**Economic and Social Council**Distr.: General
25 September 2012

Economic Commission for Europe**Inland Transport Committee****World Forum for Harmonization of Vehicle Regulations****Working Party on Passive Safety****Fifty-second session**

Draft new Regulation on child restraint systems**Proposal for Supplement 1 to the draft new Regulation on
child restraint systems****Submitted by the expert from Japan***

Appendix 3, insert a new figure, to read:

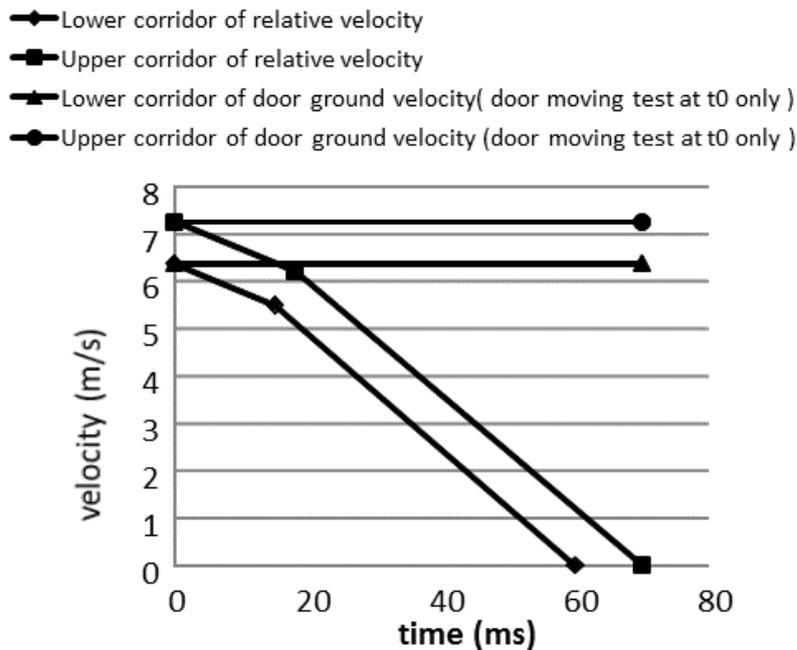
Appendix 3, the figure, shall be deleted

In the draft new UN Regulation (ECE/TRANS/WP.29/2012/53), a relative velocity between door and seat is defined as the only test condition for lateral impact testing. Such test condition, however, would generate various situations where tests with different stringency levels are possible. For this reason, the new test conditions should be added so

that only a single test situation will be generated and the stringency level will be the same in deceleration and acceleration sled tests.

"7.1.3.1.3.4. The test rig shall reproduce a relative velocity between the door panel and the test bench in compliance with Annex 7 Appendix 3. The maximum intrusion depth of the door panel is defined in Annex 6 Appendix 3. The relative velocity between the door panel and the test bench shall not be affected by contact with the CRS and shall remain within the corridor defined in Annex 7, appendix 3. **In a test where the door is stationary at time t0, the door shall be fixed and the dummy's ground velocity at t0 shall be between [6.375 m/s] and [7.25 m/s]. In a test where the door is moving at t0, the door's ground velocity shall remain within the corridor defined in Annex 7, Appendix 3 at least until its intrusion reaches its maximum, and the dummy shall be stationary at t0.**"
